PRODUCT/PROCESS CHANGE NOTICE (PCN)

PCN #: **TB1405-01** DATE: **July 7, 2014**
Product Affected: **TQFP-44, TQFP-64**
shipped in Tape & Reel
(Refer to Attachment II for affected part#)
Date Effective: **October 7, 2014**

ATTACHMENT I - PCN #: TB1405-01

Table 2: Comparison of Existing Carrier Tape and New Carrier Tape and Quantity Per Reel

From: Carrier Tape (P8-300-E64) - Pocket Dimensions

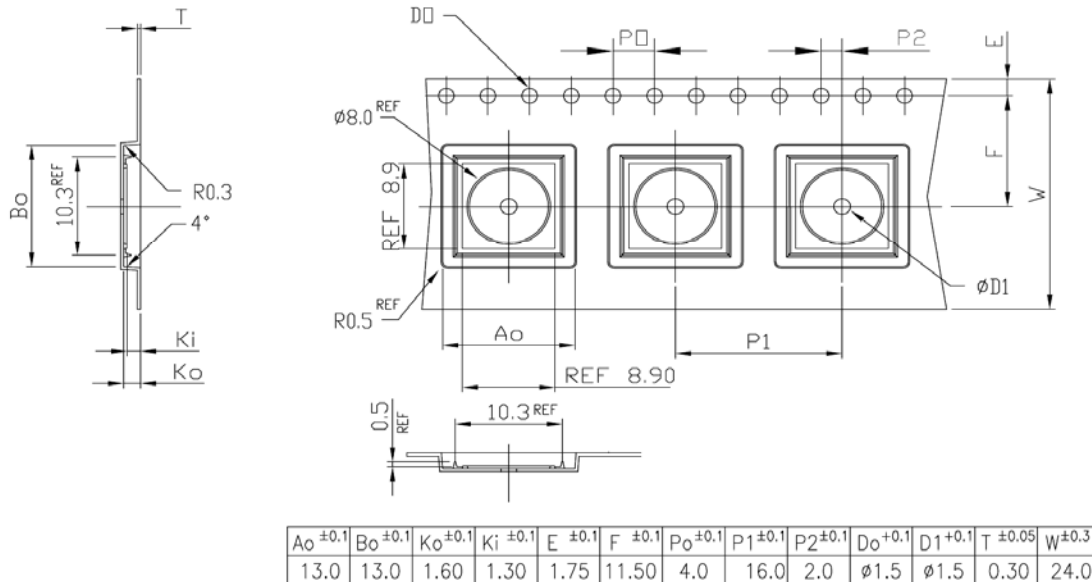
Refer to Table 2, Figure 1 and 2 for the comparison of the existing and new carrier tape in terms of carrier tape pocket dimensions and pocket designs as well as quantity per reel respectively.

| Description of Changes | From | To |
|--------------------------------|---|-------------------------------|
| Pocket Width, Ao (mm) | 13.0 ± 0.1 | 12.5 ± 0.1 |
| Pocket Length, Bo (mm) | 13.0 ± 0.1 | 12.5 ± 0.1 |
| Pocket Depth, Ki (mm) | 1.3 ± 0.1 | 1.1 ± 0.05 |
| Total Pocket Depth, Ko (mm) | 1.6 ± 0.1 | 1.4 ± 0.1 |

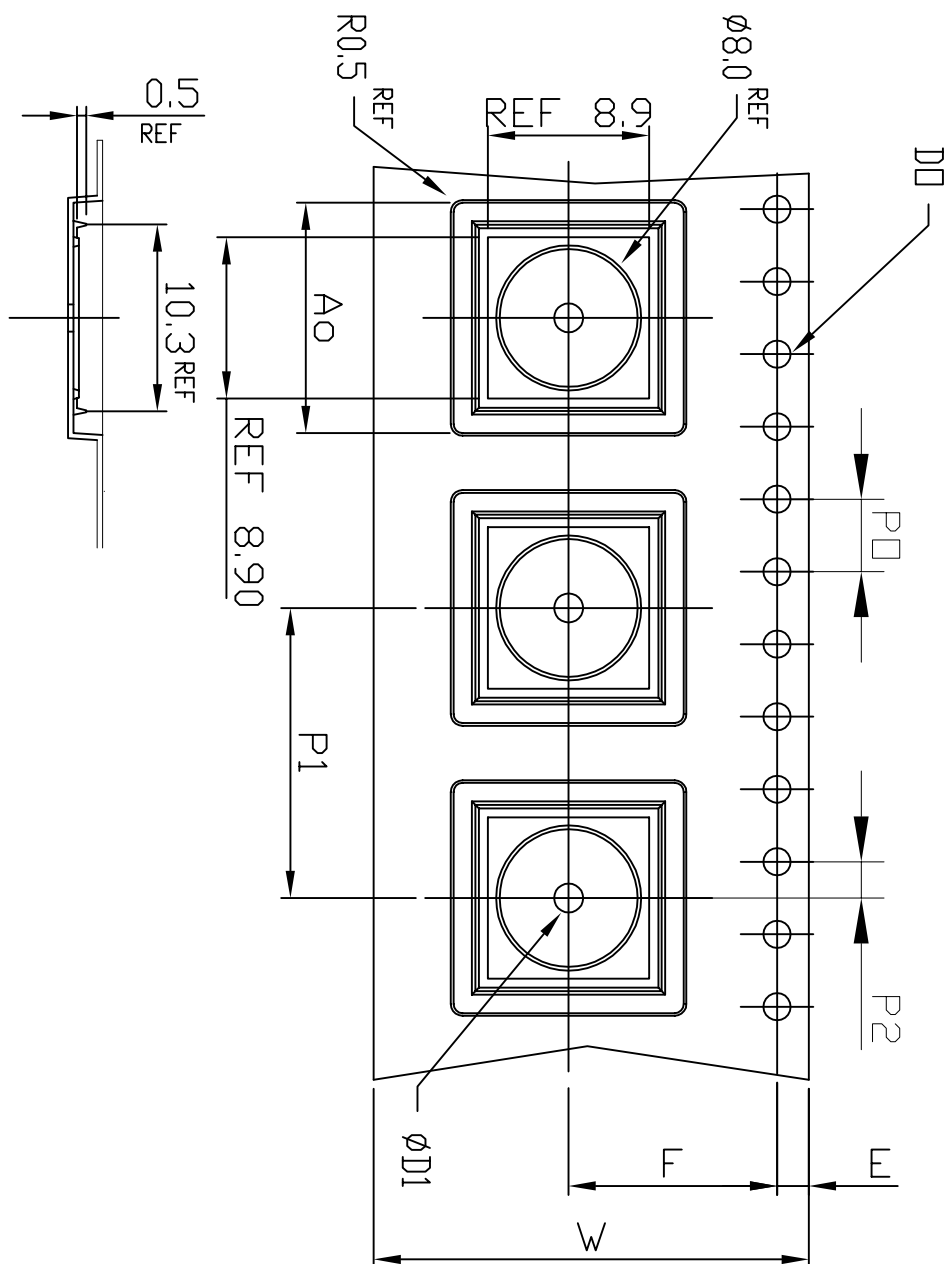
| Description of Changes | From | To |
|--------------------------------|---|-------------------------------|
| IDT Carrier Tape Drawing# | MSC-4900 | MSC-7396 |

Attachment III - New Carrier Tape Drawing

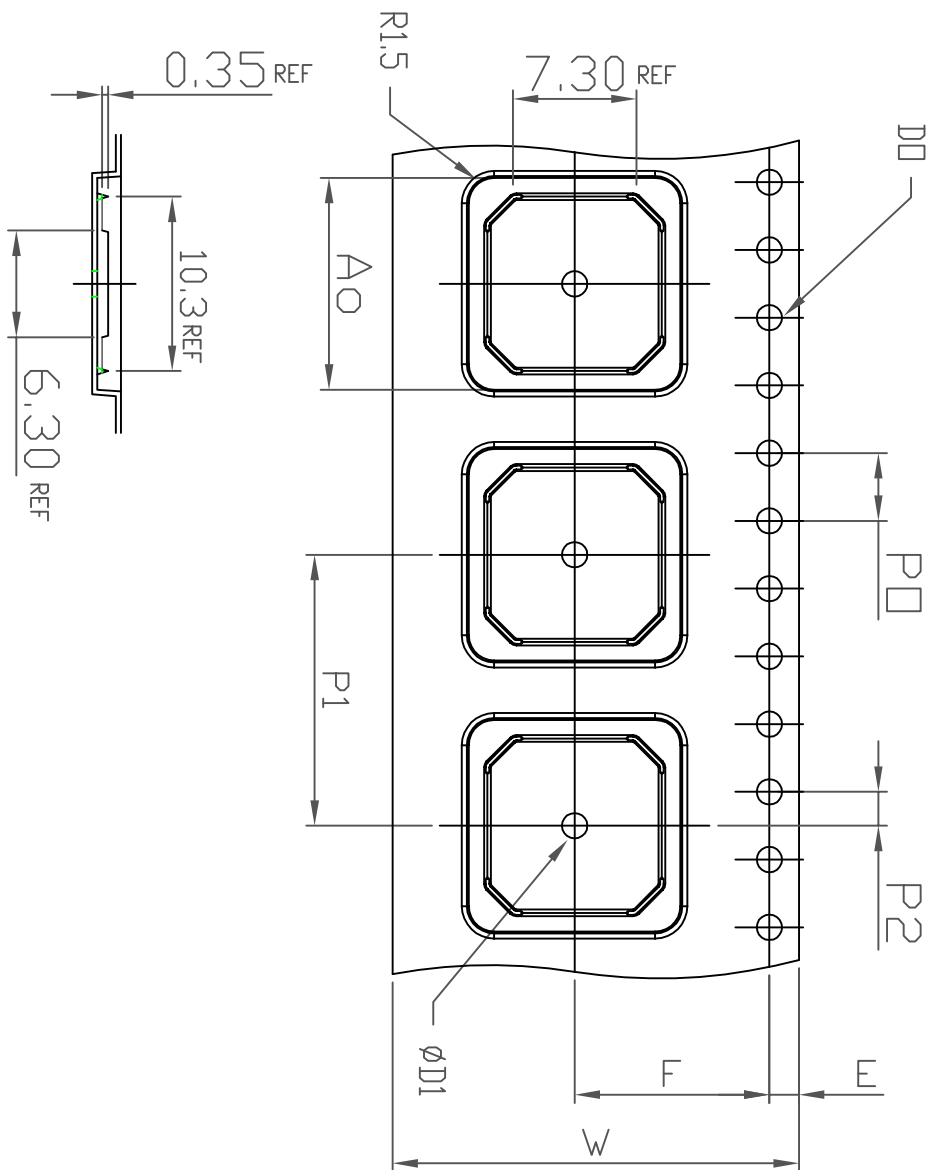
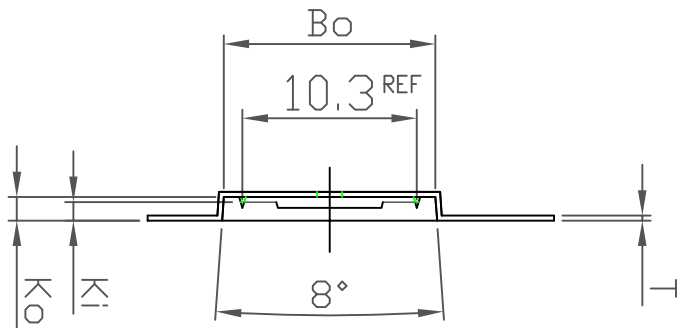
The new carrier tape has changes in pocket design and dimensions and complies with the requirements of EIA-481-D standard.
